PLOT 1, TOWNHOUSE FARM – REPLACEMENT DWELLING DRAINAGE – FOR PLANNING DOC

Drainage Information for Proposed Replacement Dwellings

Revision P4

24-080

PROPOSED DRAINAGE SITE PLAN
(1:150)

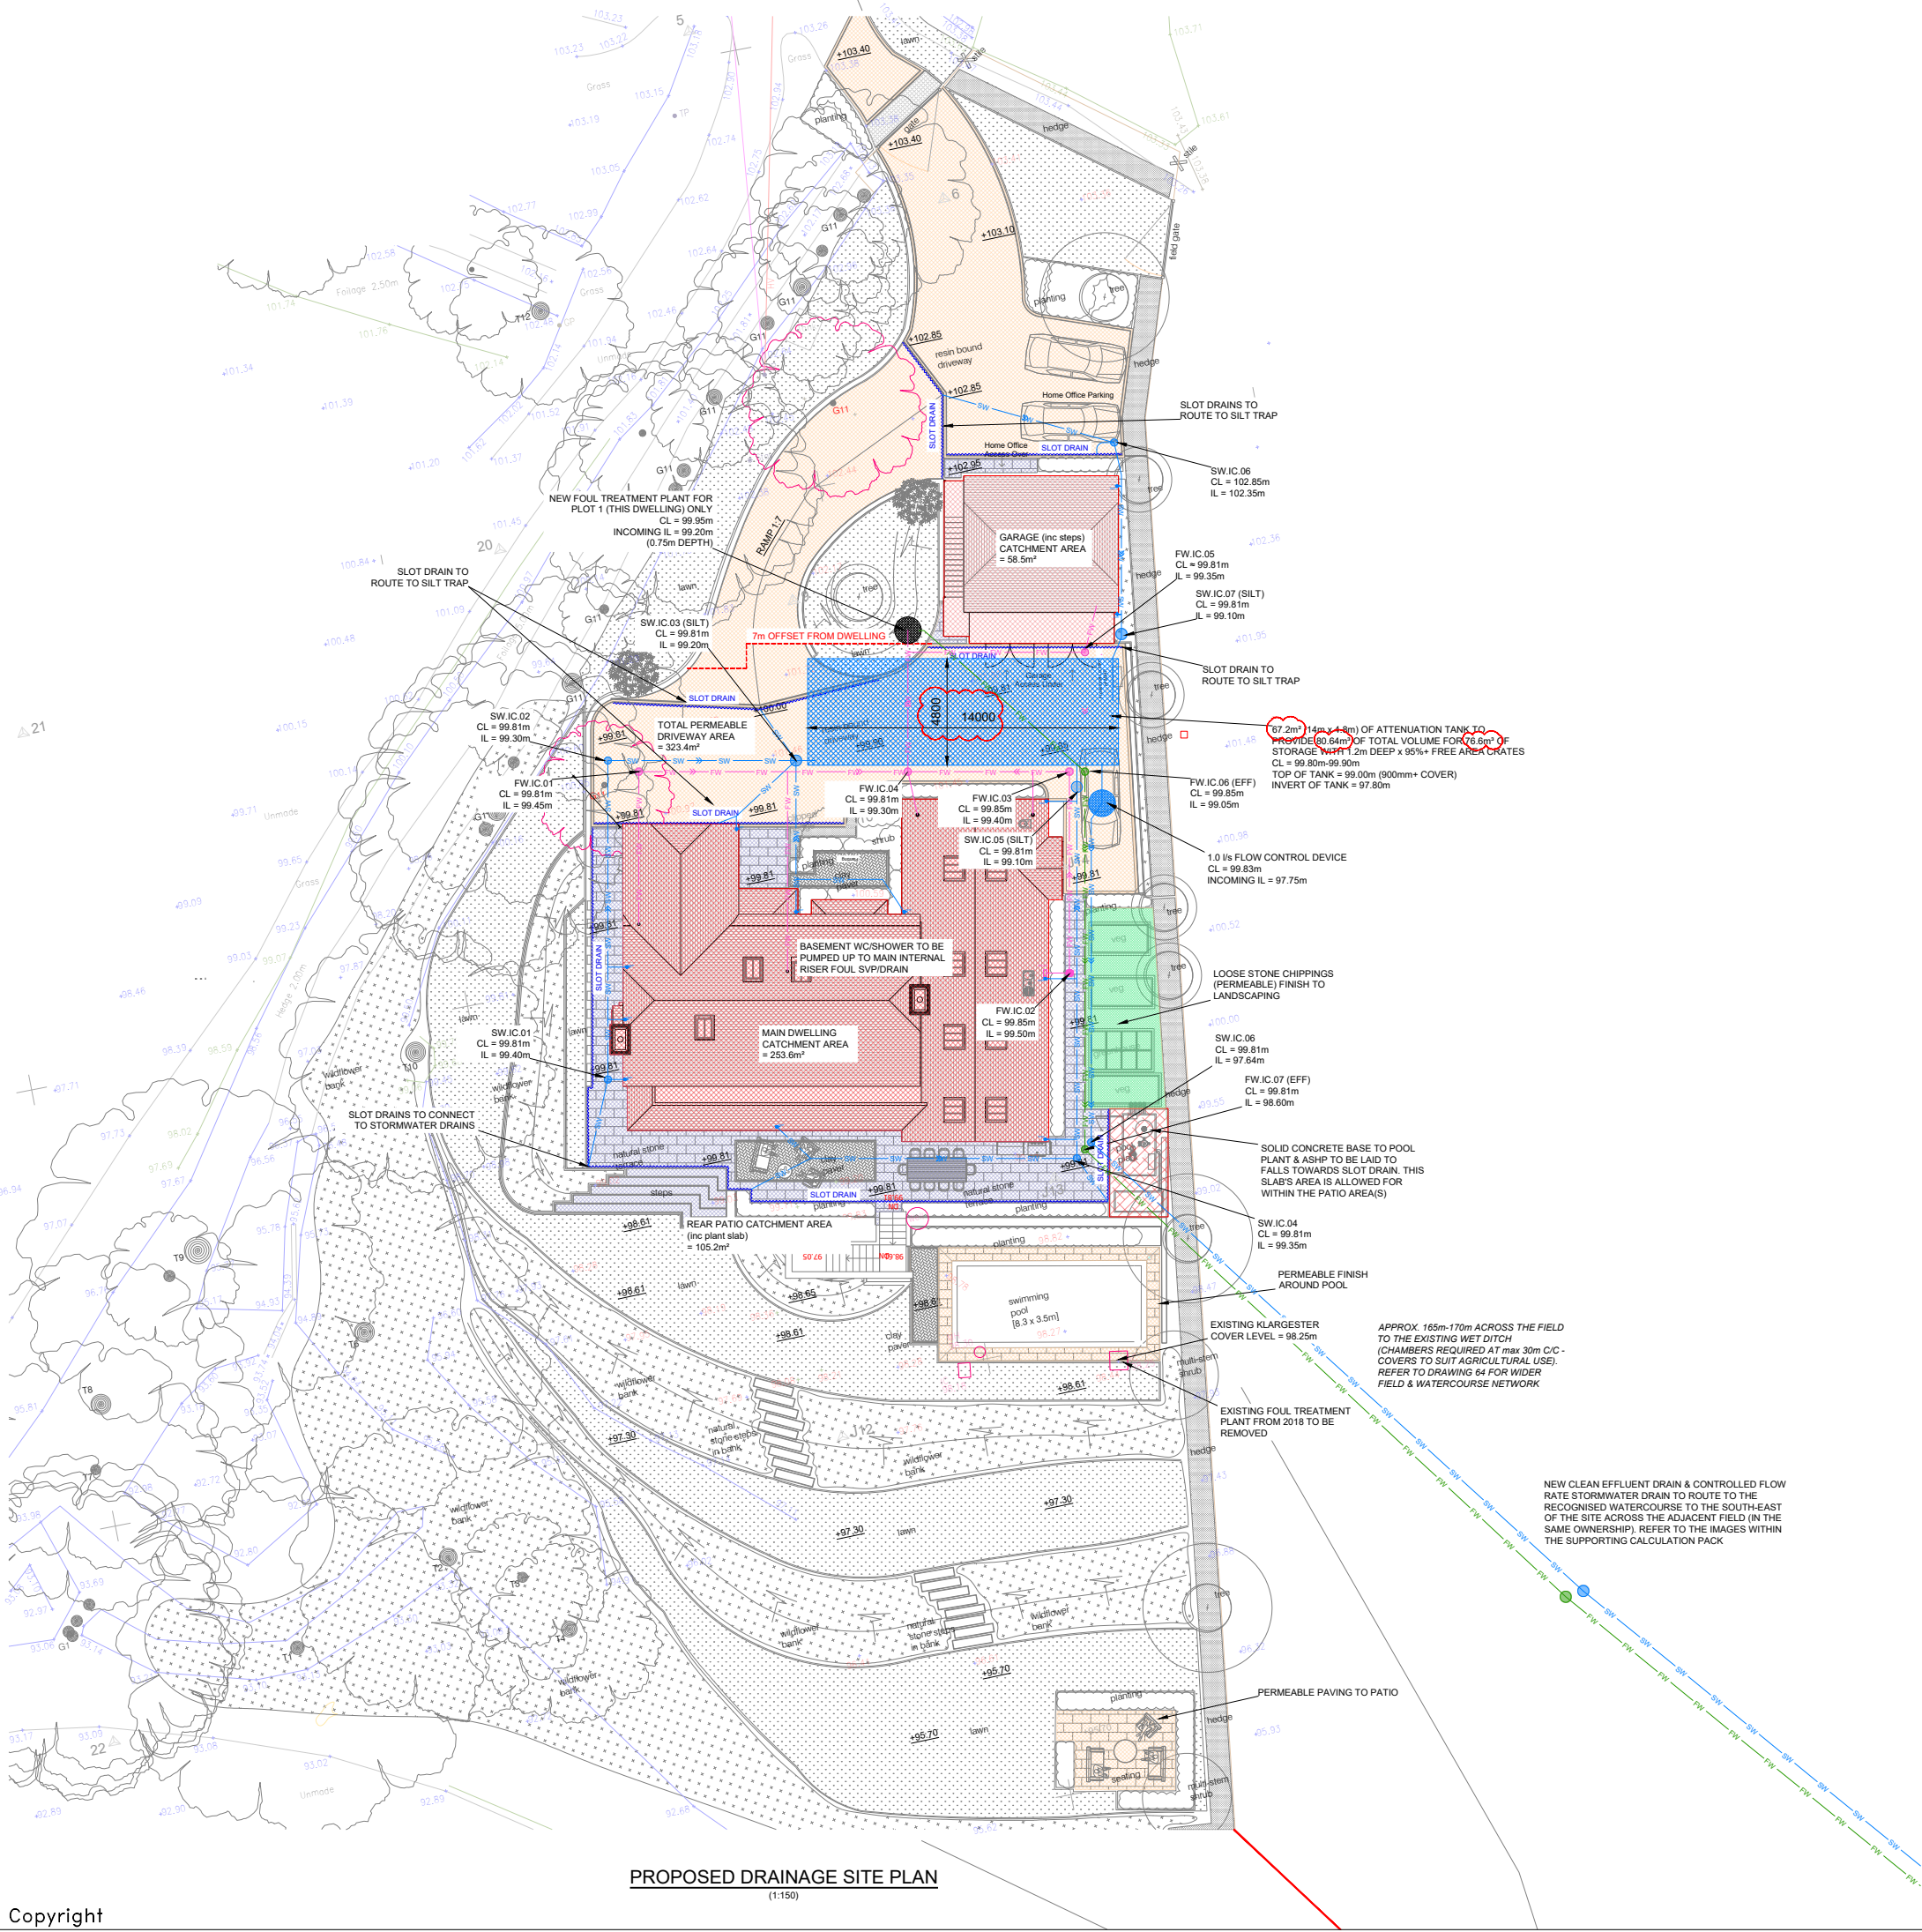
P4 – The attenuation tank volume size notes have been corrected only. Only drawing 61 has been updated with the corrected noted clouded. Section C has had the description updated, which cross references to the drawing values.

REV	DESCRIPTION	DATE	BY
P1	FOR PLANNING DOC ONLY	17.12.2024	PW
P2	NEW FOUL TREATMENT PLANT MOVED WITHIN 10m OF EXISTING WITH SURFACE WATER ROUTE TO FOLLOW FOUL ROUTE	30.06.2025	PW
P3	RELOCATED FOUL PLANT, ATTENUATION UPDATED TO SUIT RAINFALL DATA & CORRECTED AREA(S). NOTES ADDED FOR DRG 64	01.09.2025	PW
P4	TANK VOLUMES CORRECTED	17.10.2025	PW

REQUIRED ATTENUATION VOLUME TO LIMIT FLOW RATES TO 1.0 l/s IS = 74.0m³

PROPOSED SIZE IS 14m LONG x 4.8m WIDE x 1.2m DEEP. THIS PROVIDES 76.61m³ OF STORAGE VOLUME WITH 95%+ FREE AREA CRATES.

Title
**PROPOSED DRAINAGE LAYOUT
WIDER SITE PERSPECTIVE**

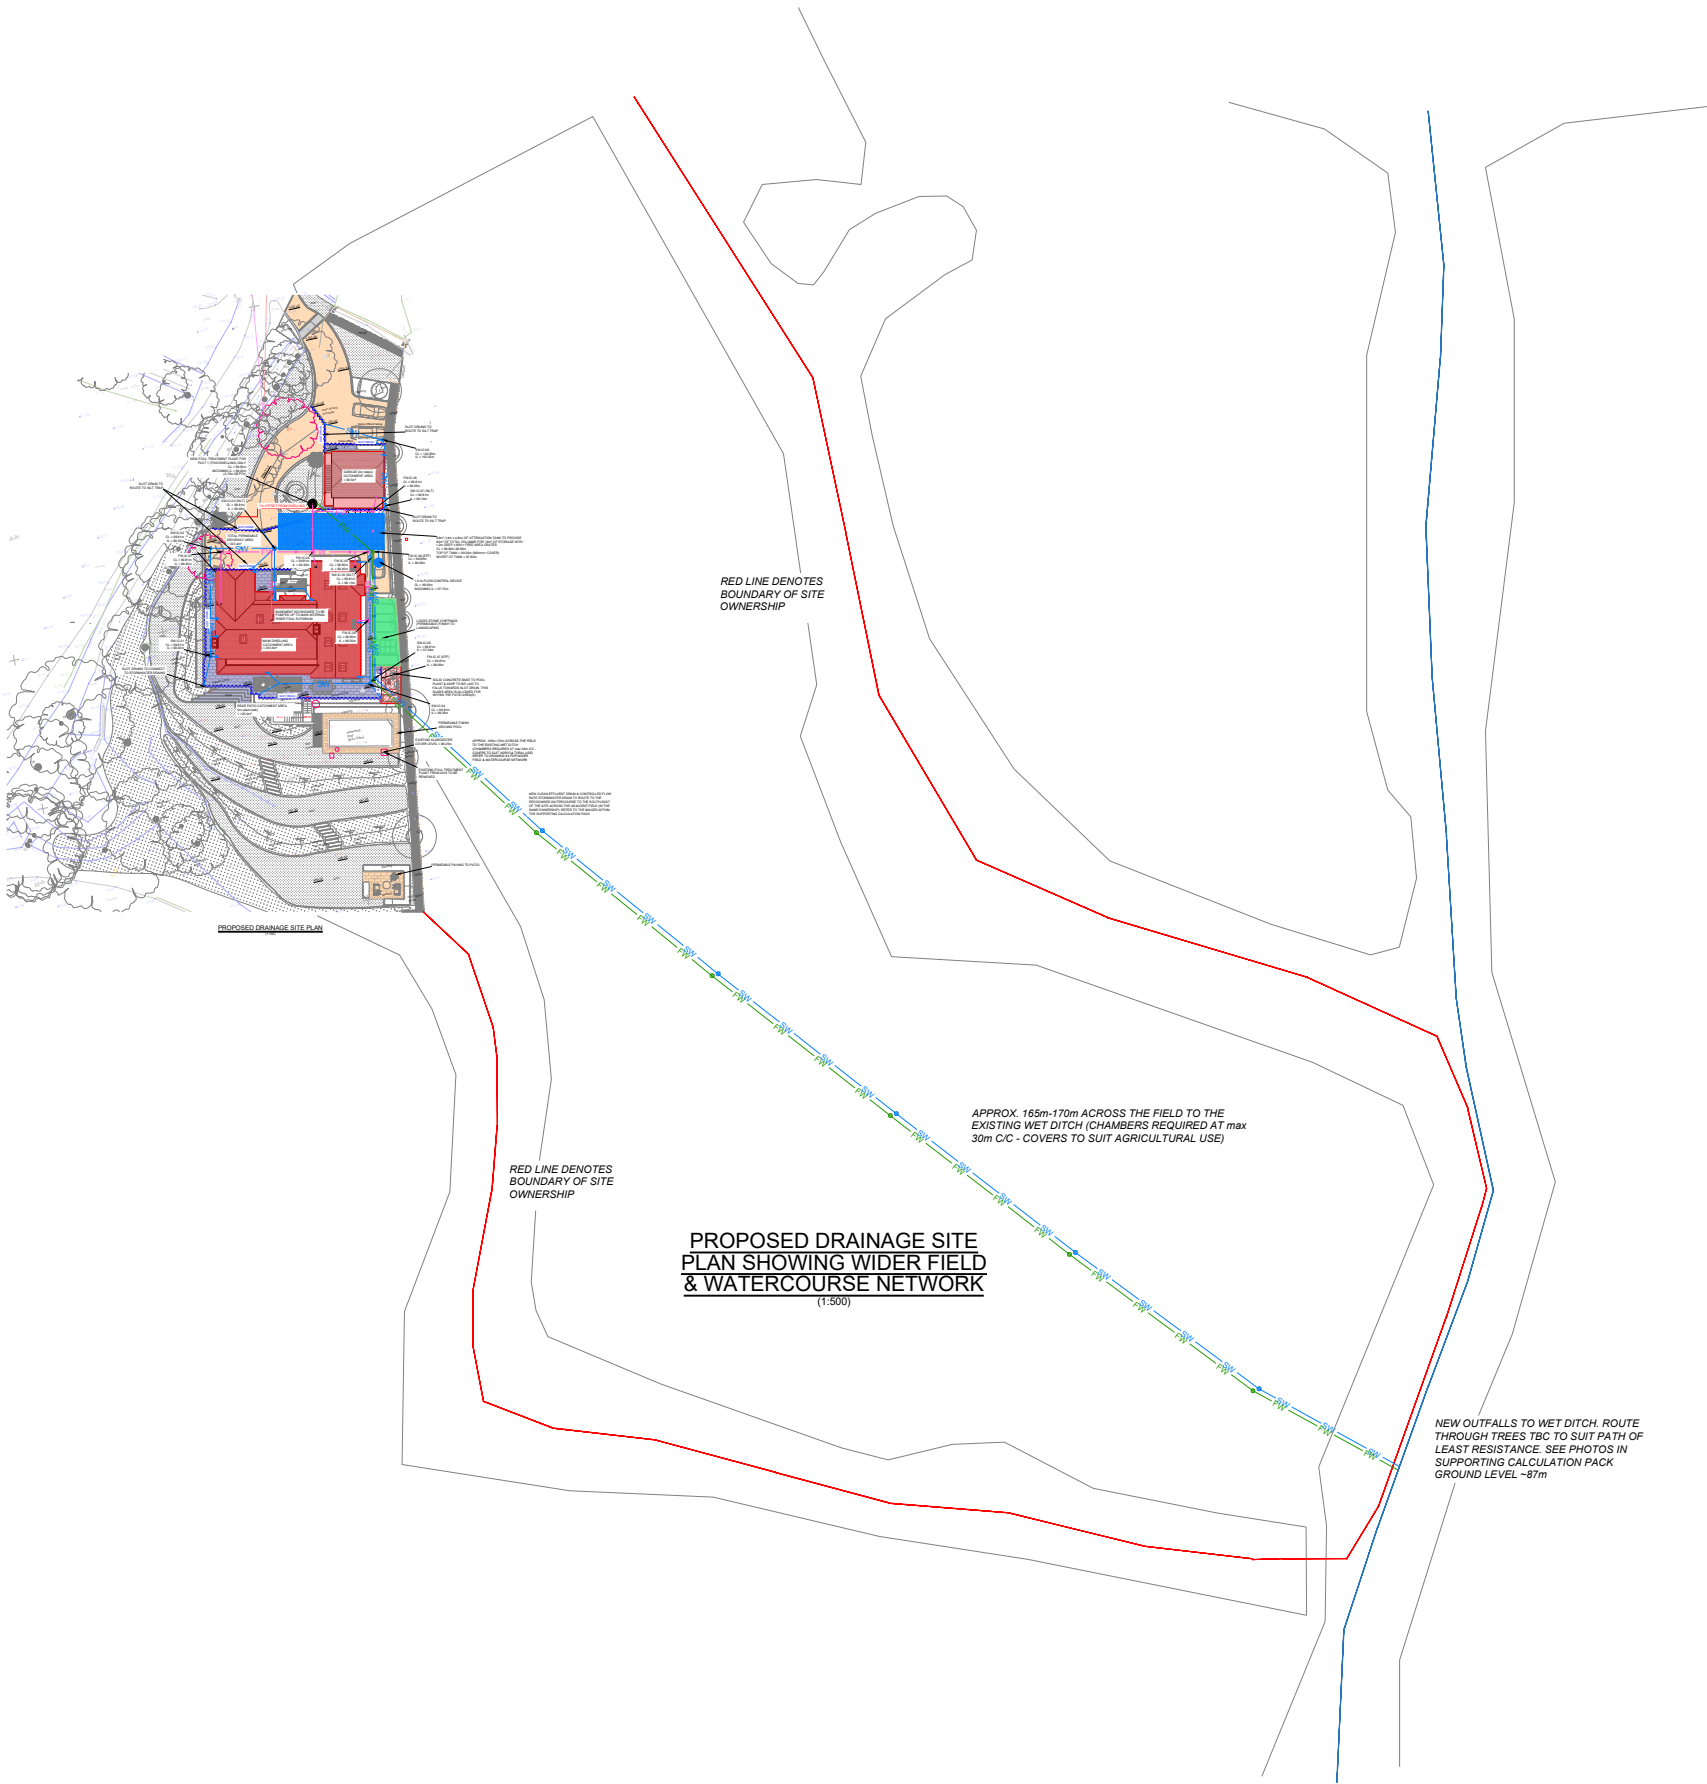
A new drawing (64) has also been created, which shows the full route across the adjoining field. This also confirms the location of the chambers and flow control chambers in the field adjacent to the proposed dwelling are within the boundary of ownership.
